Land off the A363 White Horse Business Park

**DESIGN AND ACCESS STATEMENT
ADDENDUM**

This Design and Access Statement (DAS) addendum document has been produced for Castlewood Property Ltd by Turley. It supports the revisions to the outline planning application for the proposed development on Land off the A363 White Horse Development Park (Application reference: 20/03641/OUT).

Fig. 4: Building Heights Plan

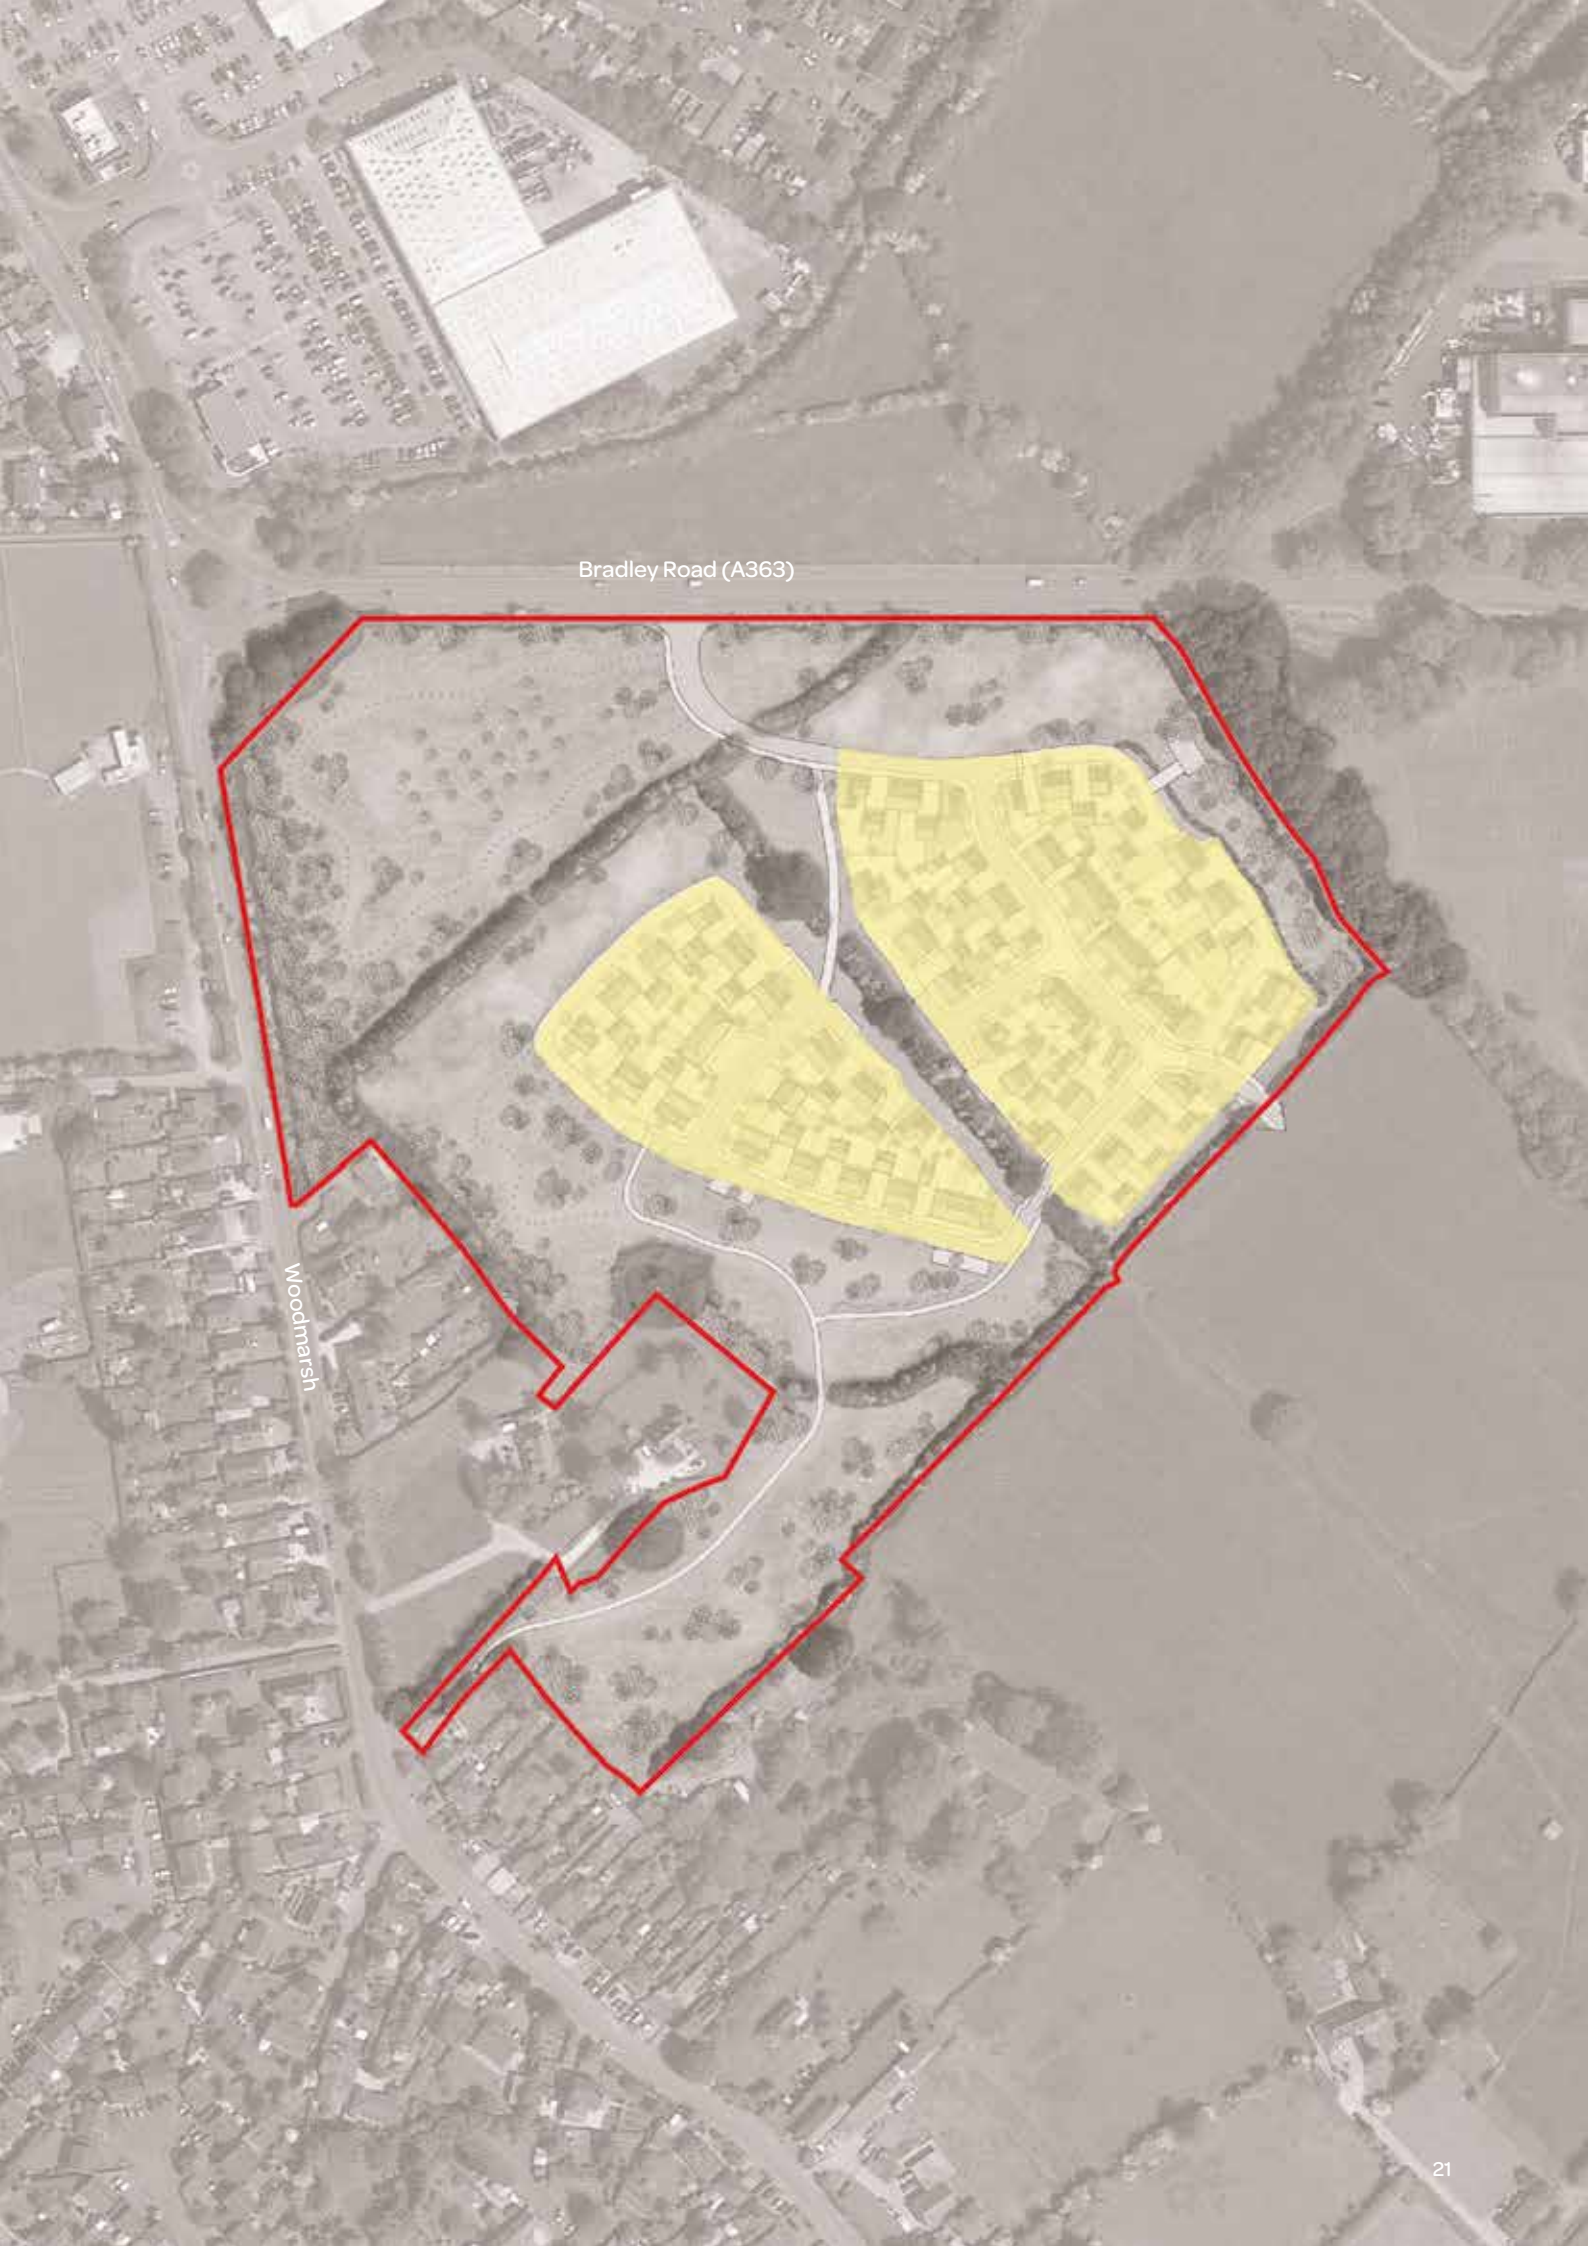
Scale/Buildings Heights - The way the layout has been conceived, it is the care home which would appear most as if in an 'open landscape' setting and yet it is proposed as 3 storeys, which highlights the contradiction in the current approach. Though as per my comments on the layout, I think development in that area should more strongly relate to Bradley Road, so 3 storeys could work OK here. Again, this is an issue best fixed within the wider masterplan exercise.	Care home use has been removed from the revised masterplan proposals.
Movement - a more detailed masterplan for whole area is really needed before assessing this. I note this is important to the highways officer too.	A wider masterplan is demonstrated on pgs. 12-13 which combines the Castlewood and Vistry layouts into one comprehensive masterplan, which helps to indicate the wider masterplan movement strategy.

Fig. 5: Proposed Movement Plan

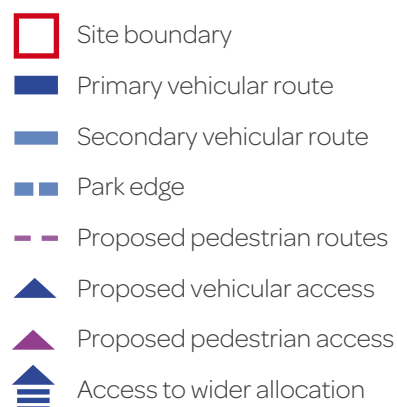
Issue Raised	Response
Movement - This plan misses important information and none of it transmits to the Parameter Plan; • Direct links to all the bus stop • Segregated cycle paths, cycle streets or otherwise, or details of min widths • All footways having links preserved through the boundaries to future paths • Pedestrian/cycle links to the business park and its employment • Recreational paths around the POS to match the extent shown on the sketch layout, and do not take in the ponds which ought to be conceived as amenity features. • Main street (function and character) needs to account for the fact that it will be serving many more homes in land to the south • Cycle paths in parameter path to link to Elm Grove Site and North Bradley	A new active movement plan is proposed on pgs 36-37 which demonstrates the site in relation to ; • Direct links to nearby bus stops • Pedestrian/cycle paths • Pavements • Recreational paths The plan helps to demonstrate how the community will have access to local facilities and services as well as employment opportunity through active travel such as walking and/or cycling, or through the local bus service.

Fig. 7: Indicative Primary Street Section

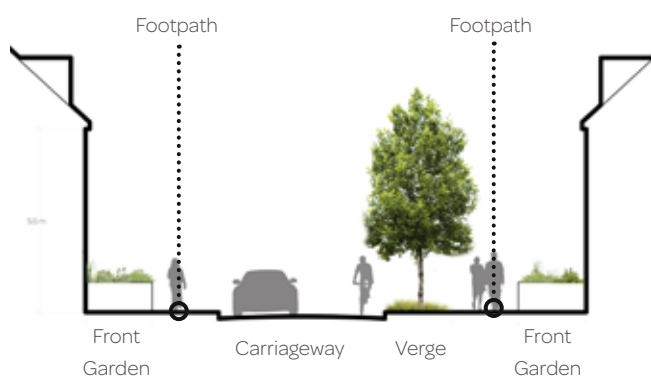
Street Hierarchy - The street sections are generic, and the sketch layout does not convincingly demonstrate the principles of them anyway, especially the issue of tree planting. The only difference between the different streets is whether a segregated footpath is included or not. Street materials/ footways materials, boundary treatments, setbacks, building forms – these all inform and enhance street hierarchy but none are discussed. Nothing is drawn from the observations of the Character Study.	The street hierarchy has been amended. This also indicates character areas. Pgs 32-35 outline the potential street characteristic of each of identified typologies. Detailed character areas will be identified within the reserved matters application, but should be based on the street hierarchy characteristics within this DAS.
Street Hierarchy - I would expect to see the street character/ hierarchy of the main street to include: • Frontages to be set back farther from main street behind some landscape frontage • Wider street to include allocated space for on street visitor parking • Continuous build line but no continuous parking • Tree lined • Sense of formal composition perhaps with architectural theme along sections of the street.	See above comment.

Fig. 11: Proposed Movement Plan

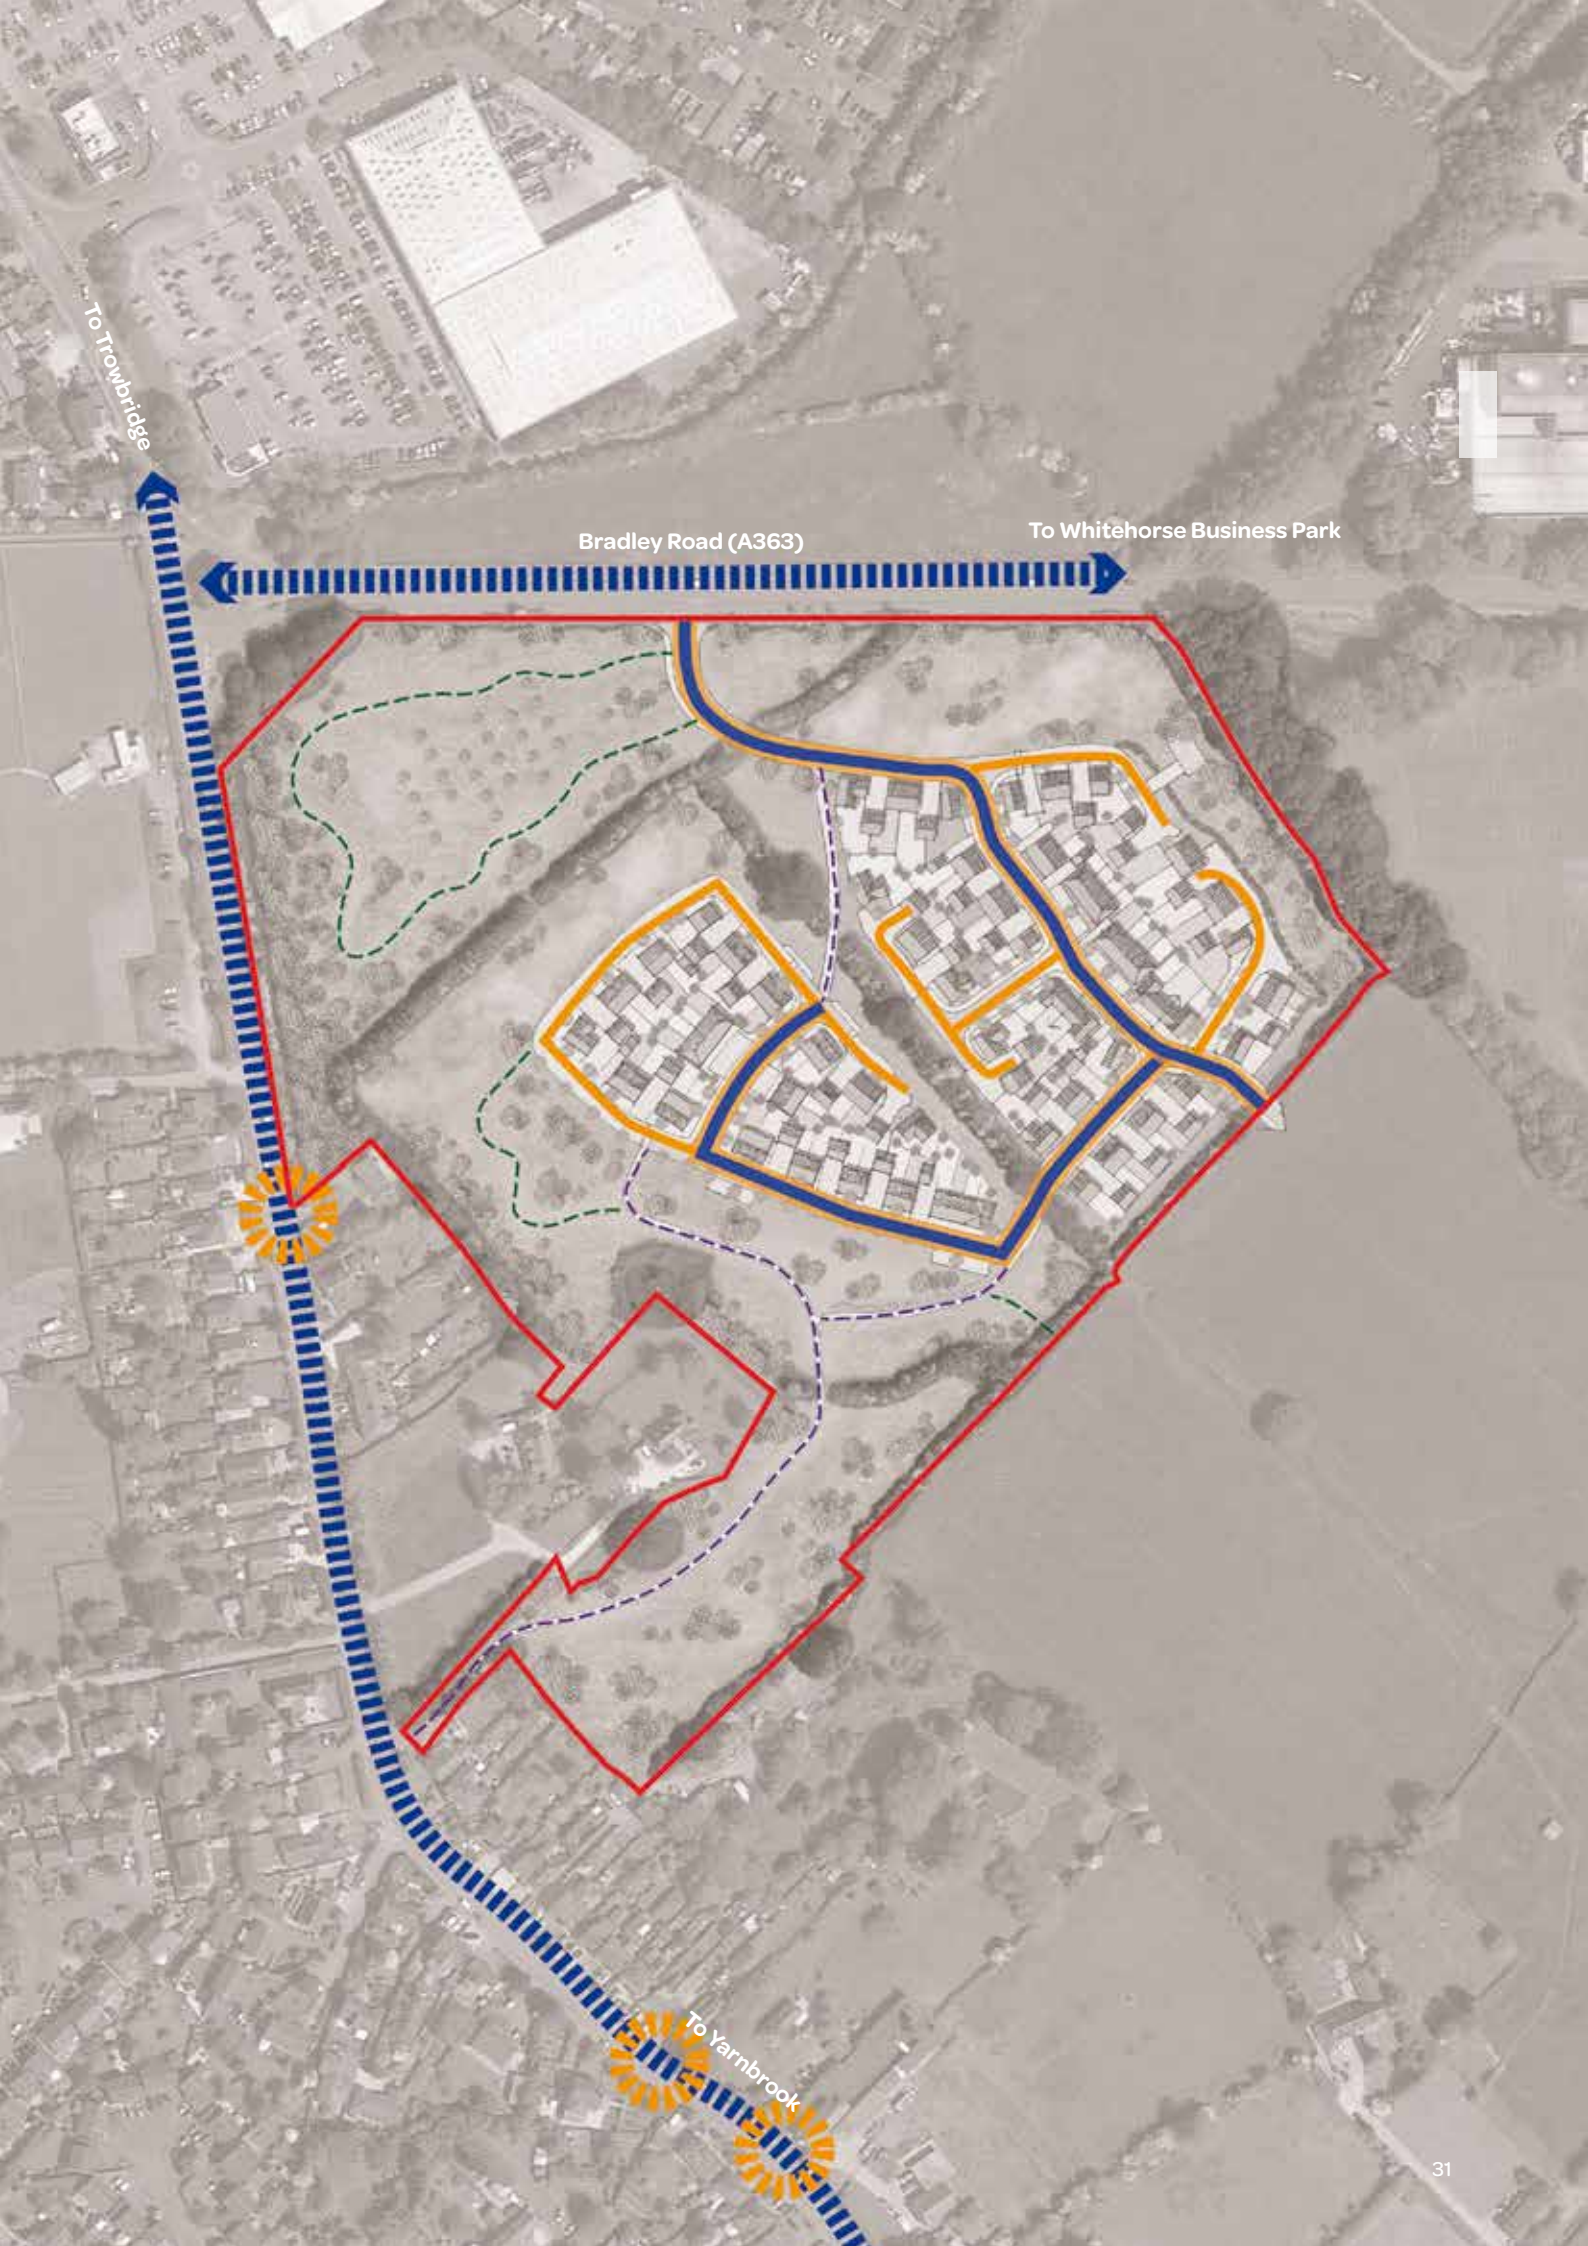
Access	
"I note the highways officer is submitting detailed comments on the access and design speed constraints for the A363. The following comments approach the access from an urban design perspective. A holistic approach to the masterplanning is recommended. For the scheme to be perceived as a continuation of the walkable settlement, and establish a new gateway into Trowbridge, and to assist in it achieving a design speed of 30mph, I believe the site should have a stronger active frontage along Bradley Road."	The revised masterplan does not seek to create a gateway approach into the town or the change the character of the A363. The most northern field of the site would remain free of development yet visual connections into the development would be made across this field. SuDS have been identified at the lowest parts of the site to mitigate existing and future flood risk, facing the A363 Bradley Road. In addition to support biodiversity and landscape recommendations, it has been proposed to retain much of the northern parcel of land as an area for ecological enhancement, which is defined by the existing hedgerow as the natural edge where development will not extend beyond. An additional pedestrian movement plan has been provided on pgs 36-37.
